# **Response to Comments Report**

Tentative Cleanup and Abatement Order No. R9-2011-0001 and Draft Technical Report for the Shipyard Sediment Site San Diego Bay

August 23, 2011

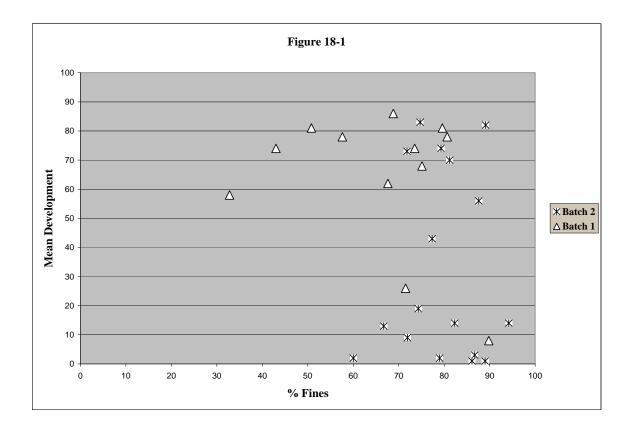
NASSCO argues that the results of the bivalve development test are given an inappropriate amount of weight in the DTR's triad analysis and that bivalve development test results should be discounted because of the experimental nature and variable results of the tests. The bivalve development test results are, in fact, reliable and weighted appropriately in the DTR triad analysis based on several considerations.

First, the laboratory that conducted the bivalve development tests concluded that "[t]he tests were validated and are acceptable for interpretation with the caveat that the Batch 2 organisms may have been more responsive to fine-grained sediments than expected" (MEC Analytical Systems, 2001). The Cleanup Team further evaluated the relationship between percent fines and percent bivalve development and determined that there was no clear evidence that fine-grained sediments were directly affecting the Batch 2 results as shown in Figure 18-1 below).

Figure 18-1 shows that while low percent bivalve development was observed with high fines content for certain Site stations, the opposite was also true. There was about an equal amount of Site stations that had high development with high fines content.

Figure 31-1 Percent Exposure Reduction versus Remediation Dollars Spent

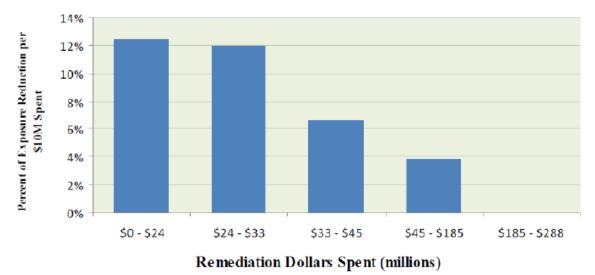
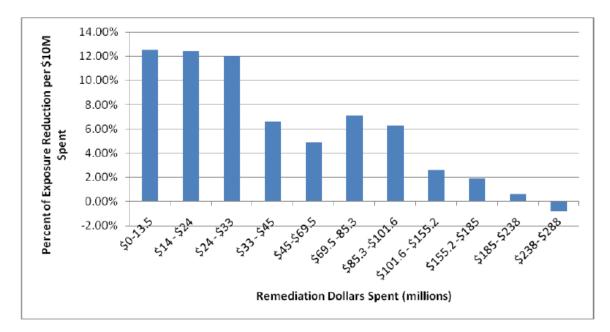
The graphic representation of the economic feasibility presented in DTR Figure 31-1 is arbitrary. Instead of graphing each of the eleven cost scenarios separately, the DTR grouped some of the scenarios together, presenting the data in the following way:

DTR Figure 31-1 would have looked different if results had been presented for each of the eleven cost scenarios.

When the cost scenarios are arbitrarily grouped, they look like this:

Here, however, regardless of whether the 11 hypothetical cost scenarios are grouped into five ranges or presented as 11 independent calculations, the underlying cost-benefit relationship is the same. In fact, EHC/Coastkeeper's Figure 1, which depicts the eleven cost scenarios graphed individually, illustrates the same trend that is apparent in DTR Figure 31-1, and lends credence to Regional Board's determination that cleanup to background is economically infeasible. Specifically, under both scenarios, the benefit per dollar spent is relatively high and flat for the first three scenarios, but decreases dramatically with the additional cleanup associated with scenario 4 (i.e., above \$33 million total cost), suggesting that cleanup above \$33 million total cost is not economically feasible, given the minimal incremental benefits. In fact, cleanup beyond the economically feasible point as defined in the DTR results in an exposure reduction of less than 7 percent per \$10 million spent after \$33 million; less than 4 percent after \$45 million; and zero at \$185 million. Exposure reductions of merely a few percentage points do not justify the expenditure of tens of millions of dollars, and would clearly violate Resolution 92-49's economic feasibility provisions.

Figure 1 Percent Exposure Reduction versus Remediation Dollars Spent

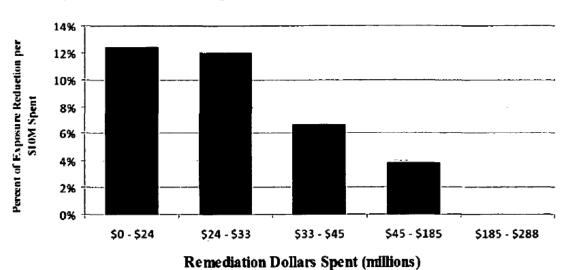
The Regional Board concluded that initial expenditures returned a relatively high exposure reduction benefit, but additional expenditures yield progressively lower returns per dollar spent on remediation. Figure 1, which is an accurate reflection of Figure 31-1 in the DTR, graphically demonstrates the percent exposure reduction versus remediation dollars spent.

The highest net benefit per remedial dollar spent occurs for the first \$33,000,000 (18 polygons remediated), based on the fact that initial exposure reduction is above 12% per \$10,000,000 spent. Beyond \$33,000,000, however, the exposure reduction per dollar spent drops consistently as the cost of remediation increases. For cleanup to background, overall exposure reduction is only 3.5% per \$10,0000,000 spent, and there is effectively no net exposure reduction for the last sets of polygons that would be included in such a remediation. Figure 2 illustrates the increasing costs and diminishing benefits associated with cleanup to background. Data shown in this figure are from Table 1.

Figure 2

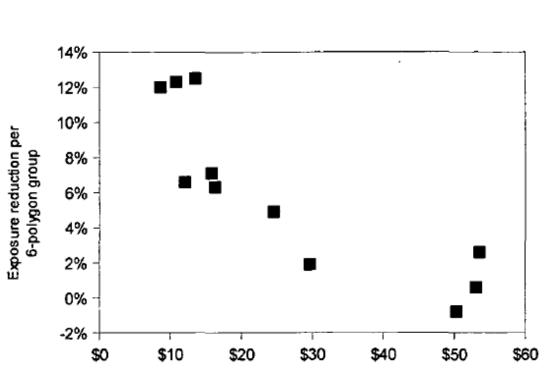
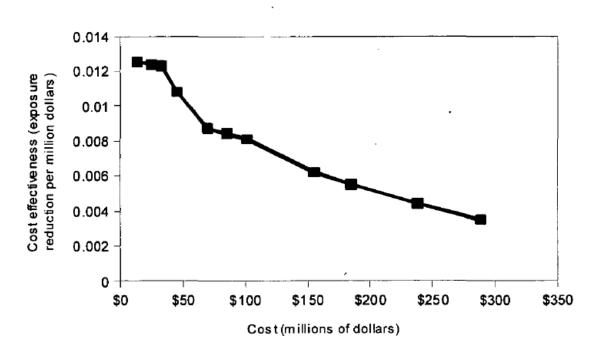
The data table above shows the incremental and cumulative benefits and costs of conducting a sequential, "worst-first" cleanup of shipyard sediments. Remediation of the polygons with the highest chemical concentrations—those in the upper left of the figure—would yield not only the greatest exposure reduction (more than 12% for each set of polygons), but also the most cost-effective cleanup. Remediation of the polygons in the lower right of the figure, which would be the last addressed in a cleanup to background, would produce little or no exposure reduction, yet would be among the most costly to clean up. The marginal benefit of cleaning up to background is small or zero, whereas the marginal costs are the highest.

Further expenditures eventually reach a point where exposures reduction benefits become negligible. SDC and EHC assert that the Regional Board needs to identify the exact point where exposure reductions become negligible. The Regional Board is not so required. The objective of Finding 31 is merely to determine whether achieving background sediment quantity is economically feasible. It is sufficient to point where the incremental cost of achieving further reductions and contaminant concentrations exceed the incremental benefit of so doing.

# <u>Figure 4</u>

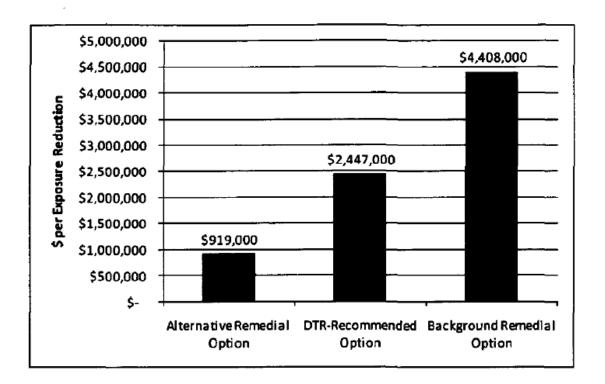
Figure 4 below, which is an accurate replication of Figure 5 in the Arcadis report, demonstrates the incremental costs and incremental reduction in exposure relative to background levels, measured in percent of the five primary COCs for the increasingly larger remedial footprints. The cost per exposure reduction (measured relative to background levels) increased from about \$900,000 under the Alternative Remedial Option (smallest remedial footprint) to about \$2,300,000 under the DTR-recommended Option. The incremental cost per exposure reduction under the Background Remedial Option increased to almost \$4,400,000 (using a 3% discount rate). The incremental cost per exposure reduction increases in cost by almost 100%, if a cleanup to background is commenced. The differential in cost per exposure reduction increases even more when social, habitat and business impacts are factored into the analysis.

Figure 5

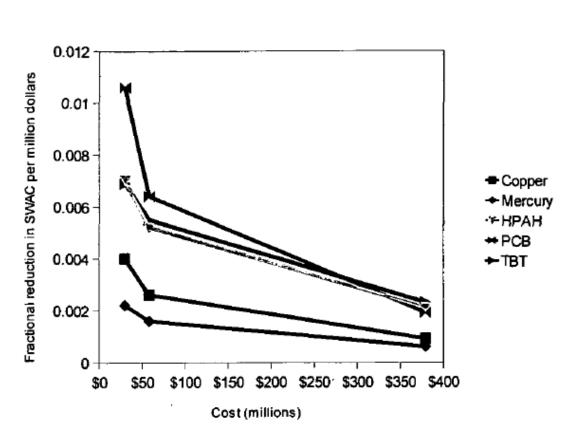
These results of chemical-specific cost effectiveness calculations show that the DTRrecommended Option is less cost-effective than Arcadis' Alternative Remedial Option, but is more cost effective than cleanup to background for all chemicals. This conclusion is consistent across all methods of interpreting cost effectiveness. Further, it is important to note that none of these methods of interpreting cost effectiveness account for the social costs, such as the impact to the community, habitat, and businesses that will be generated as a result of the cleanup level ultimately adopted by the Regional Board. Therefore, it is likely that the actual costs associated with each of the available options are understated, and the lack of cost effectiveness of cleaning to background is that much greater when all remediation costs, social and actual, are fully taken into account. Nevertheless, consistent with the determination in the DTR that cleanup to the proposed footprint is more cost effective for each of the primary COCs at the Shipyard Site.

Coastkeeper/EHC Figure 3. Percent Pollution Exposure Reduction Per \$10 million, by Pollutant and in Continuous Dollars, with Background Marked.

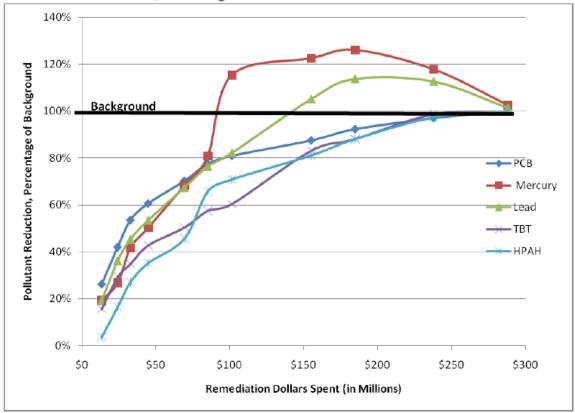
Coastkeeper and EHC commented that the economic feasibility data was not presented in a scaled manner. DTR Figure 31-1 presents the economic feasibility analysis in a bar graph with percentage pollutant reduction per \$10 million spent on the Y-axis, and remediation dollars spent on the X-axis. But by using a bar graph, readers cannot tell the true relationship of the data points to one another over a continuous basis (dollars spent). To fairly represent the data and to observe the trends of where significant pollution reduction occurs per dollar spent and where the pollution reduction per dollar spent decreases, the results must be graphed on a continuous X-

axis. Once the data is plotted as a scatter graph on a continuous x-axis, we can truly see the percent reduction compared the remediation dollars spent.

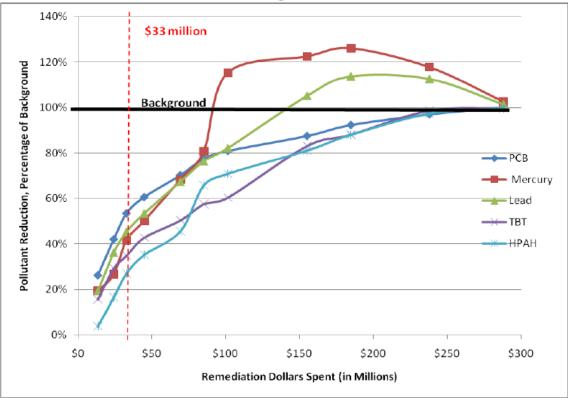
In rebuttal, NASSCO commented that the analysis presented in EHC/Coastkeeper Comments, Figure 3 differs only in form from that presented in EHC/Coastkeeper Comments, Figure 2. It contains no additional information, other than the inclusion of background as a reference point. Consistent with the bar chart, a slope change in the plotted figure (i.e., a decrease in benefit per unit cost) can be seen at approximately \$33 million total cost. The benefit/cost ratio generally continues to decrease with costs above this point.

Figure 31.1 Percent Exposure Reduction versus Remediation Dollars Spent

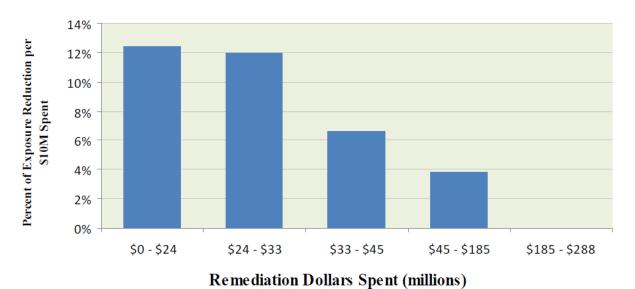
Figure 31-1 clearly shows that when the least contaminated polygons are added to the footprint (scenario 11), exposure reduction is negligible compared to the cost of cleanup. Figure 31-1 also shows that cleaning up the first 18 polygons at a cost of about \$33 million yields the highest exposure reduction per unit cost compared to the other scenarios. The \$58 million estimated cost of the remedial footprint cannot be directly overlaid on Figure 31-1. This is because different methods and assumptions were used to derive the remedial footprint and alternatve cleanup levels compared to the evaluation of the feasibility of cleaning up to background. For example, the analyses of economic feasibility to cleanup to background used all 66 polygons, including NA22 (which was later removed from consideration), and the three polygons determined to be technologically infeasible to dredge. The statement in Section 32.7.1 that "[C]leaning up additional areas beyond the proposed remedial footprint would yield about 4 percent additional exposure reduction per \$10 million spent" may not be justified and will be revised. A more reasonable interpretation of the economic feasiblity analysis as it relates to the remedial footprint is that the \$58 million cost estimate for the cleanup of the proposed remedial footprint, which consists of 23 polygons, is at a point beyond the initial high exposure reduction per cost scenario represented by the first 18 polygons. The cost effectiveness analysis in the Arcadis Report also supports this conclusion. Thus, the Cleanup Team is satisfied that the alternative cleanup levels are the lowest that are economically achievable in light of the "total values" analysis required by Resolution No. 92-49.
